Site Plan

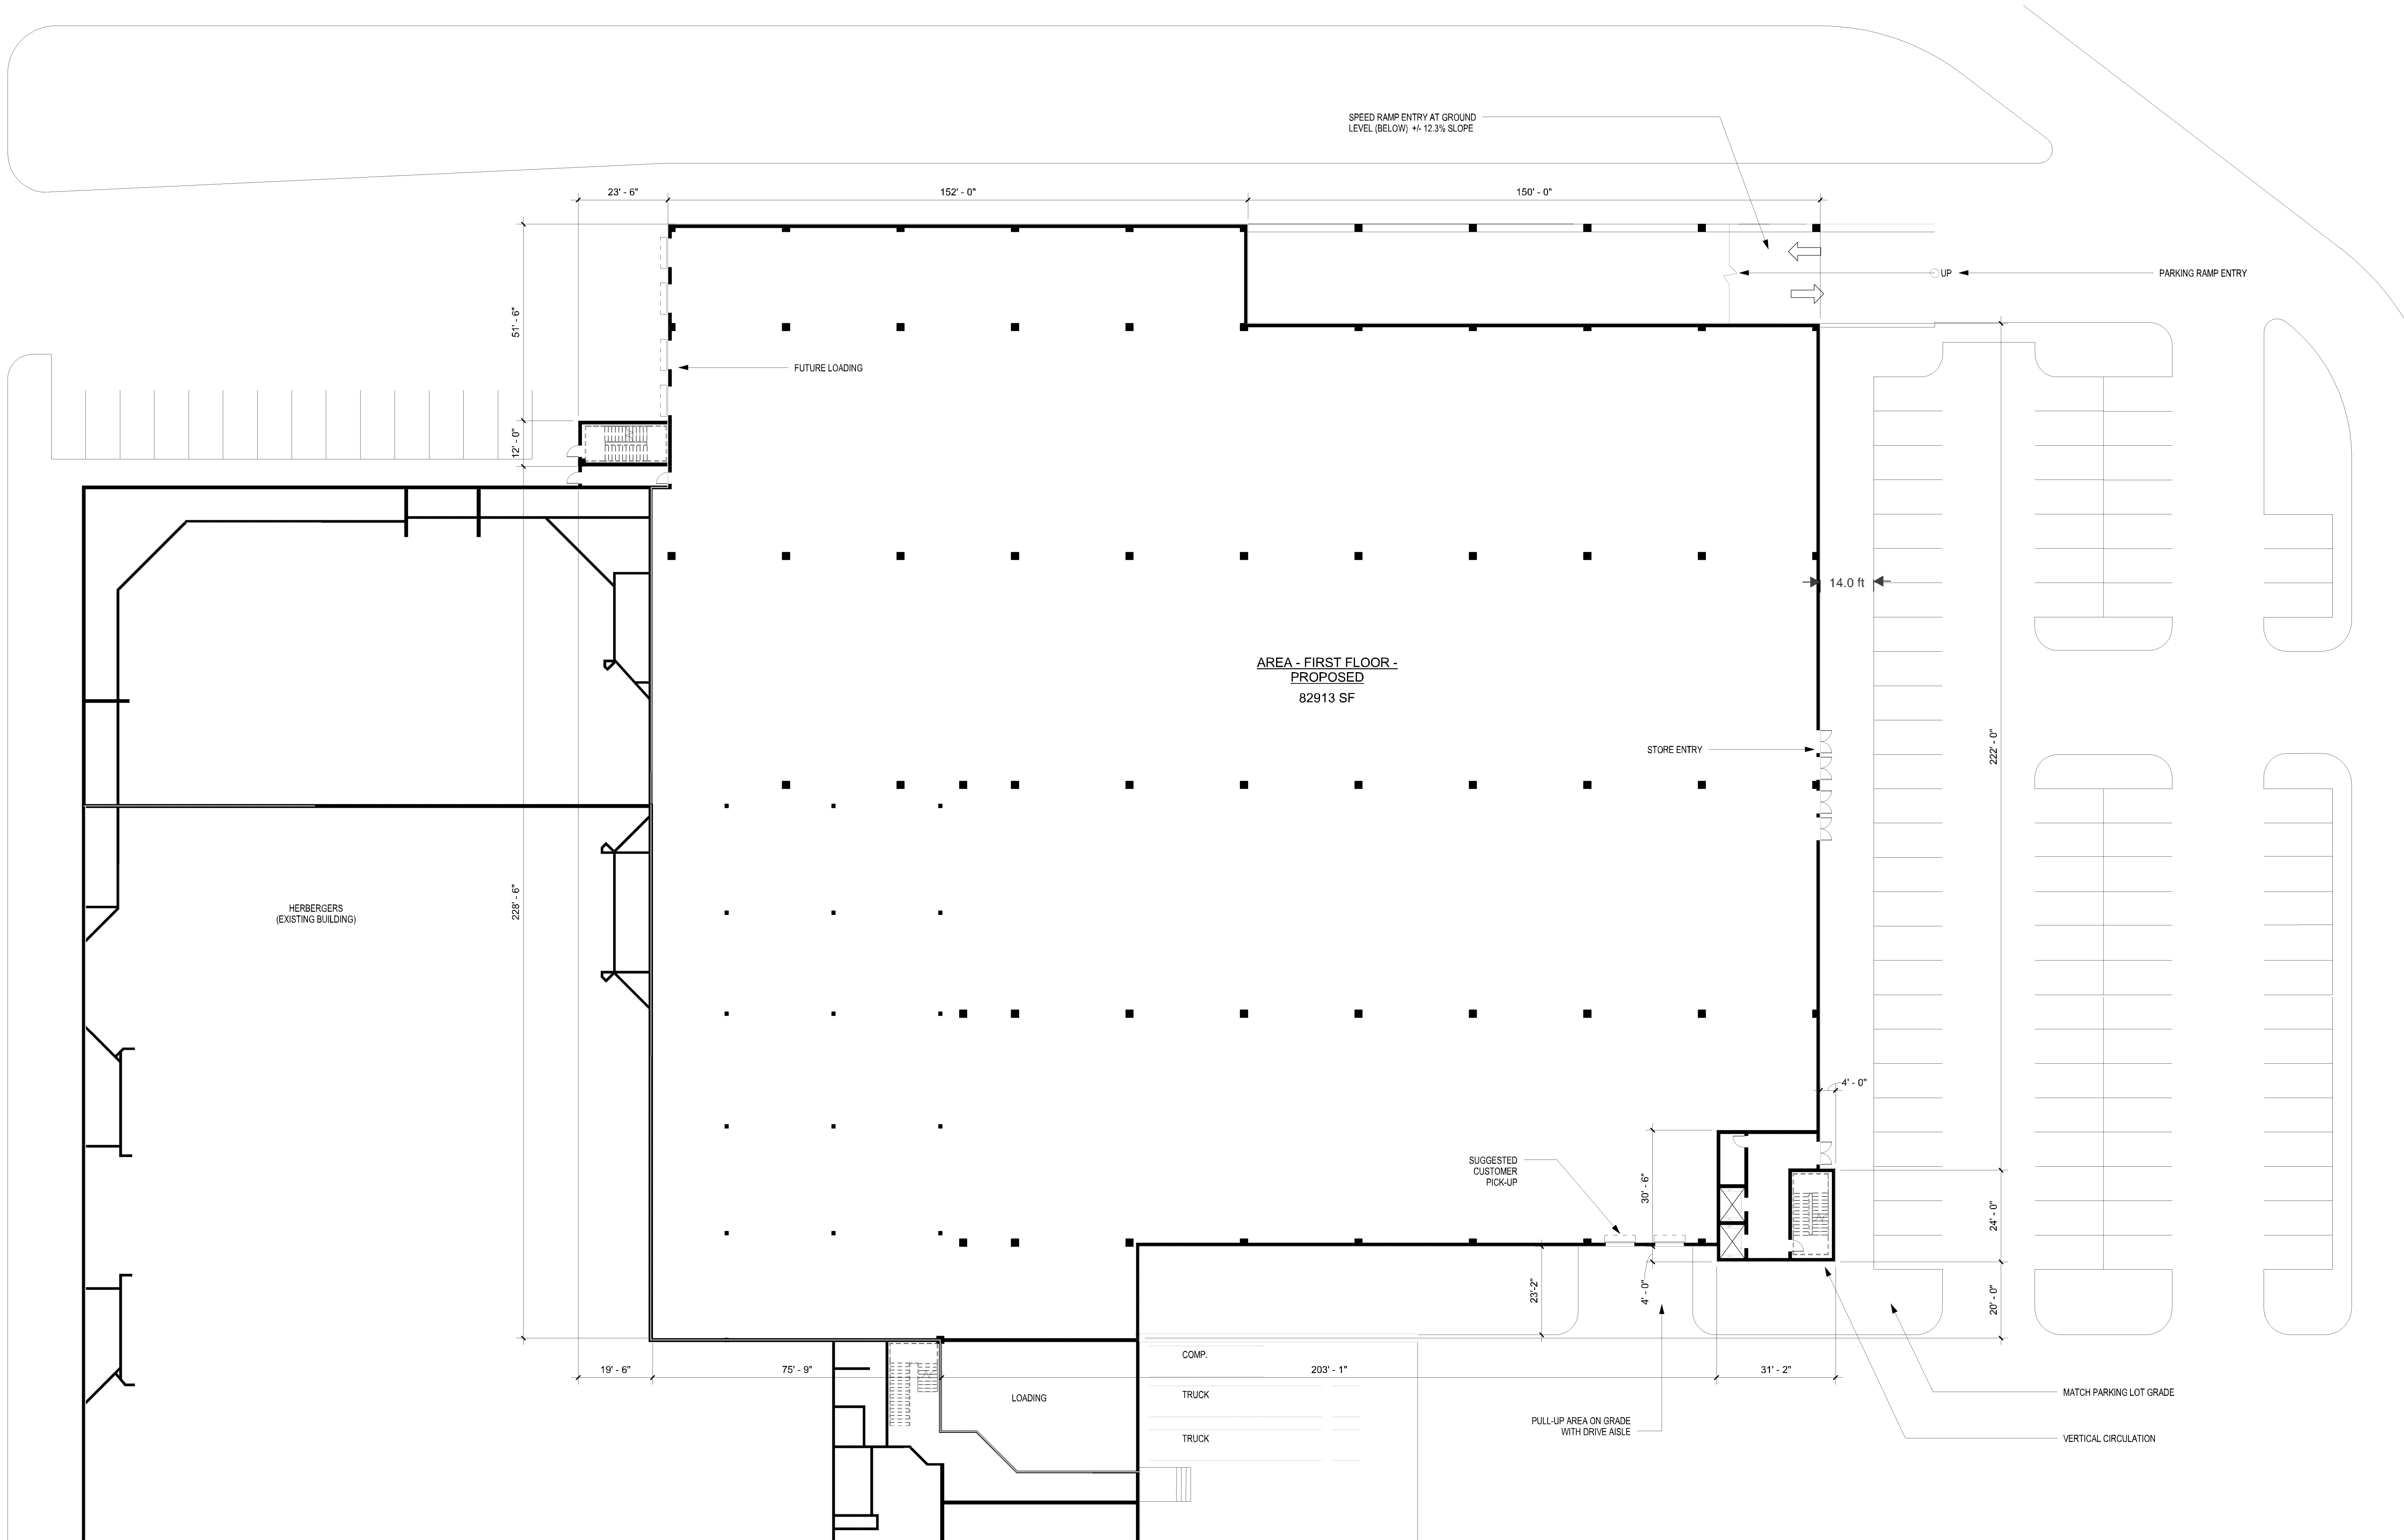
Circulation between the shopping center to the west and the new proposed parking may not be possible in the future when MnDOT uses their ROW that contains the existing Southtown Drive. Suggest showing plan for making the circulation work when this access outside of the property is removed in the future.

Maintain adequate emergency vehicle access and turn radius throughout the property.

Emergency responder radio coverage shall be provided per appendix L of the MSFC.

Hydrants required within 150' of all areas of the building and within 50' of the FDO.

Show existing utilities on site and provide 12" water main loop and hydrants for fire protection.

North Arrow - Scale??

Please include the number of bowling lanes in the chart so staff can confirm the parking calculation is correct.

Does the total retail square footage represent gross building area or leasable? City Code calculates parking on gross building area.

Please clarify the existing "omitted" parking stalls versus the parking stalls provided. It is unclear how parking is being altered.

Provided the parking inputs are correct, the project would exceed the parking requirement.

Provide more detail on the parking calculations. What is included in this "Retail"? Is all of Herbergers included? You cannot access Herbergers entrance from this area. Need more information to accept proposed reductions.

Because the Lucky 13 parking is separate from the parking analysis, please confirm the restaurant seats are not included in the chart. Also, please include the Lucky 13 seat count so there is a total picture of parking demand.

Preliminary Perspective Sketch

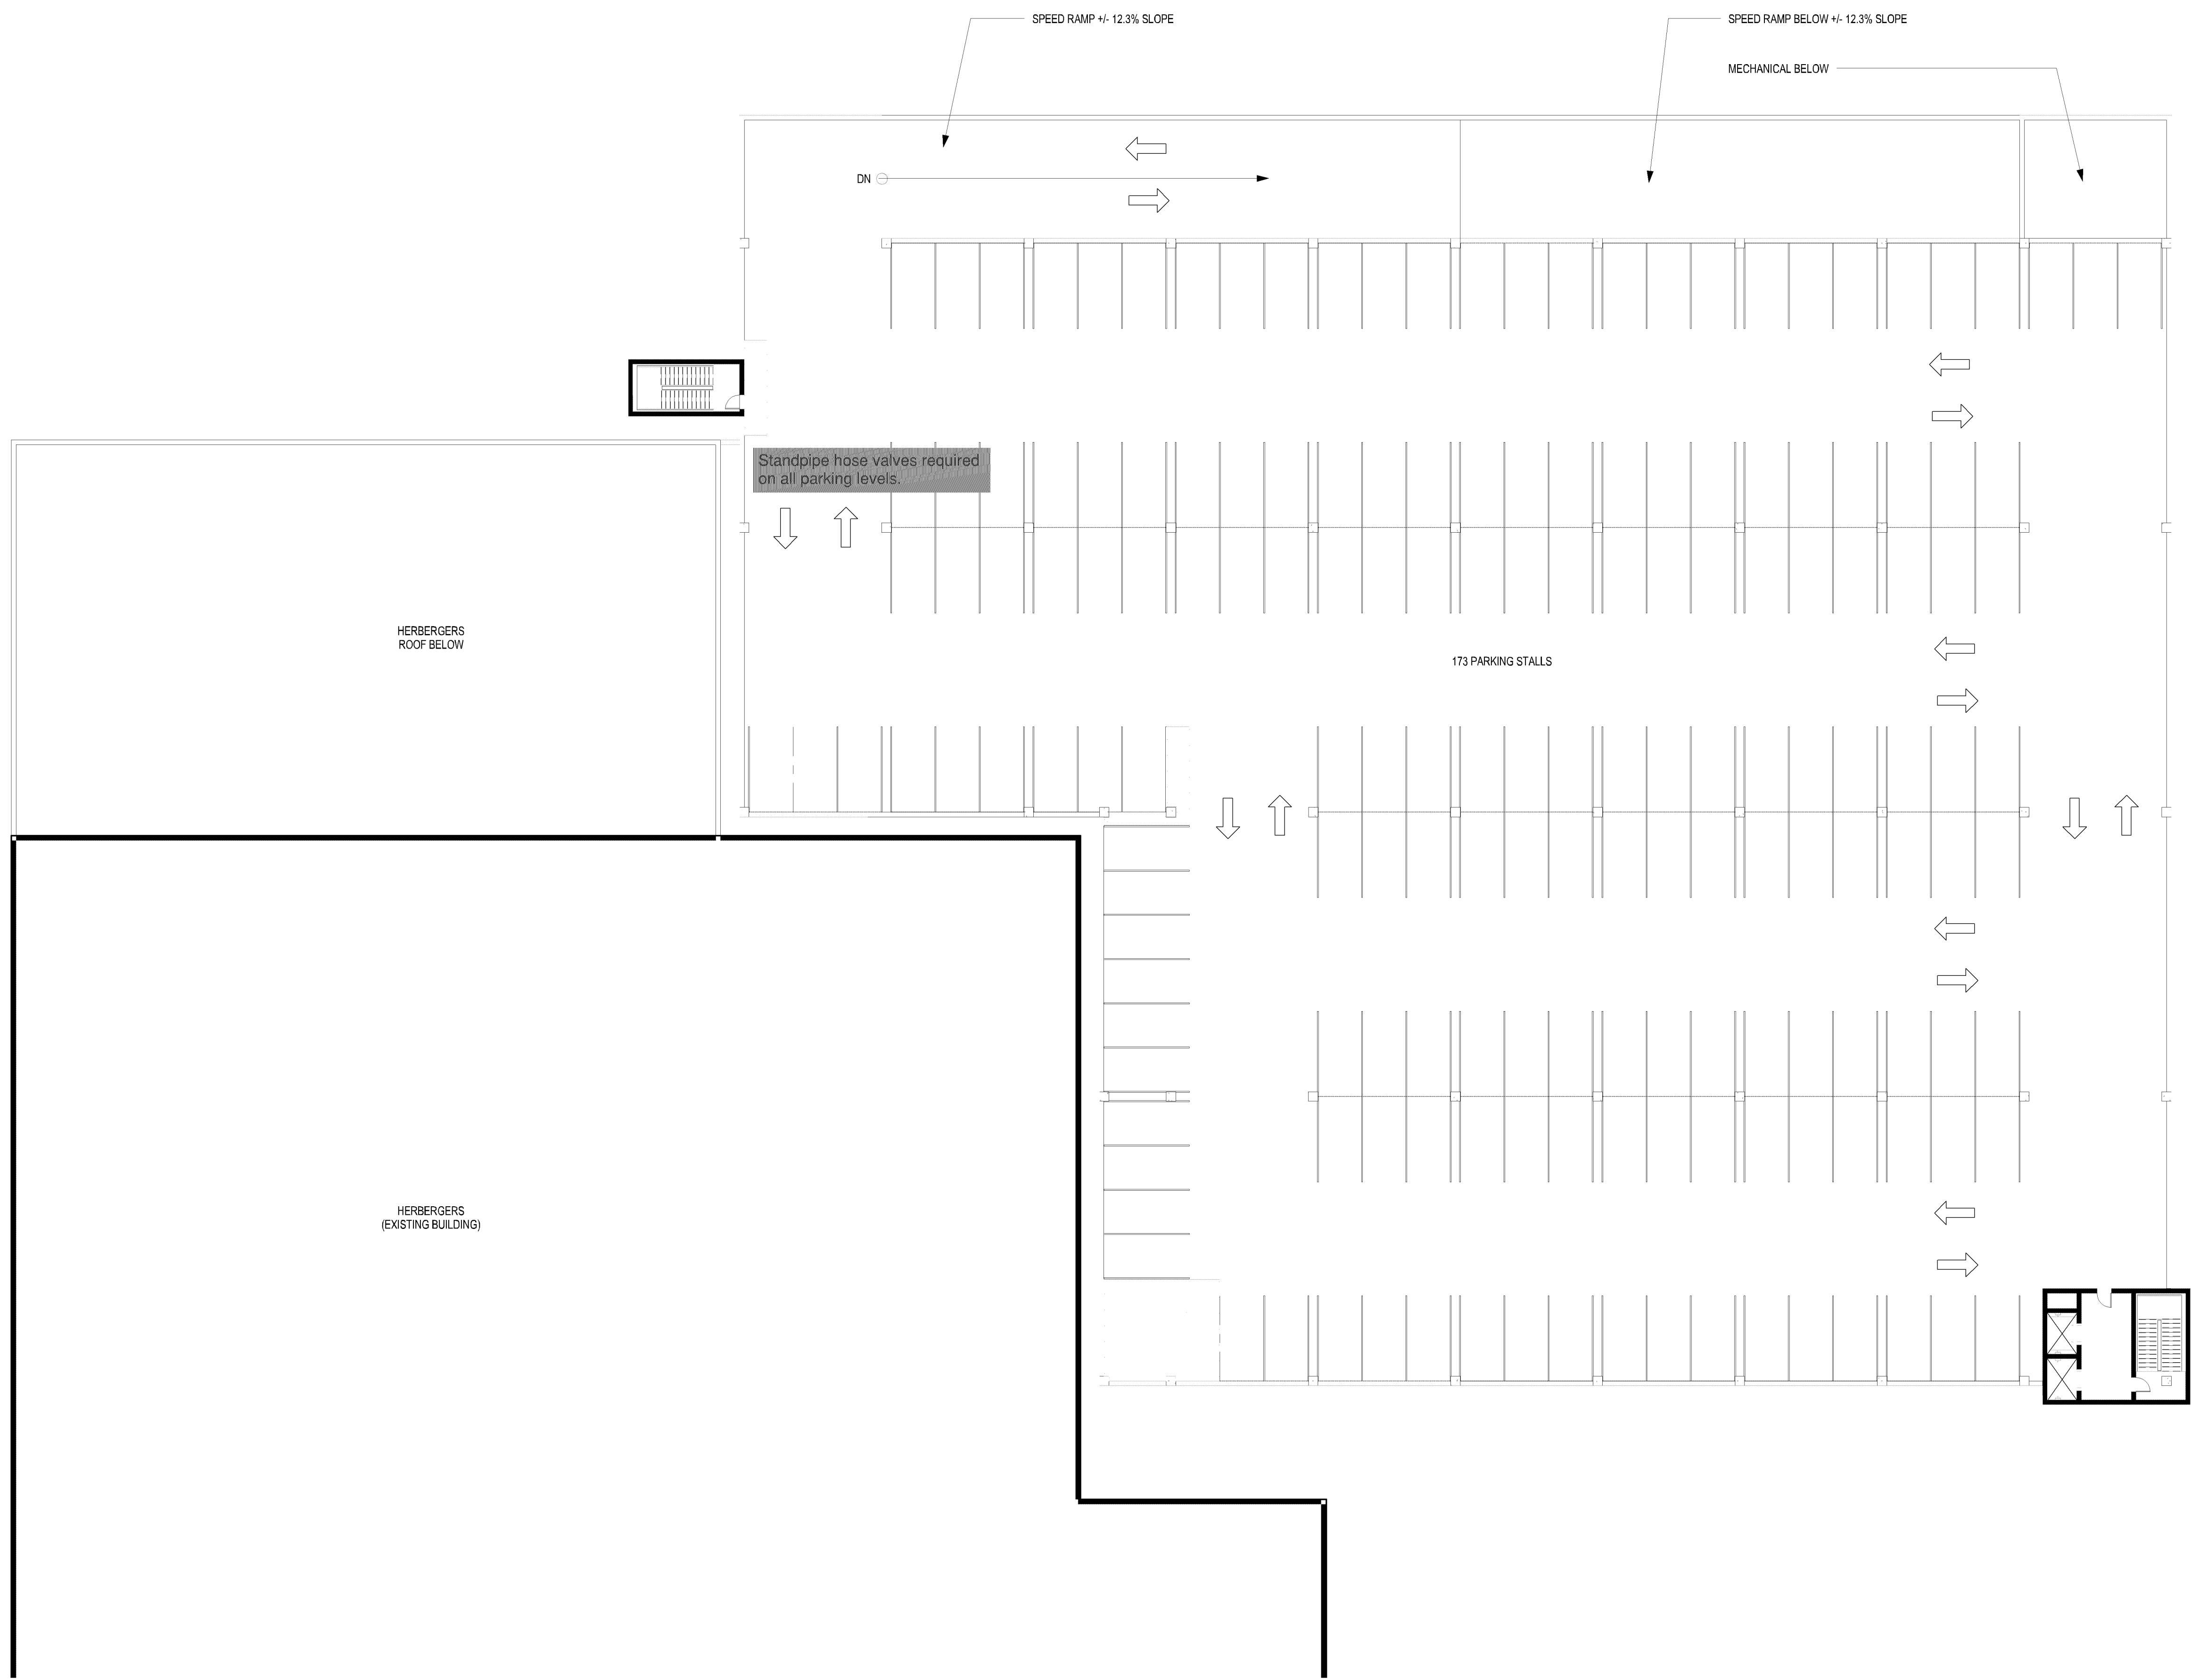
Signage is not permitted above building roof lines or on parking structures. The elevator shaft may be a good option for elevated signage.

The Southtown Shopping Center uniform sign design is in need of an overhaul. This project affords the opportunity to review the signage plan for the entire shopping center.
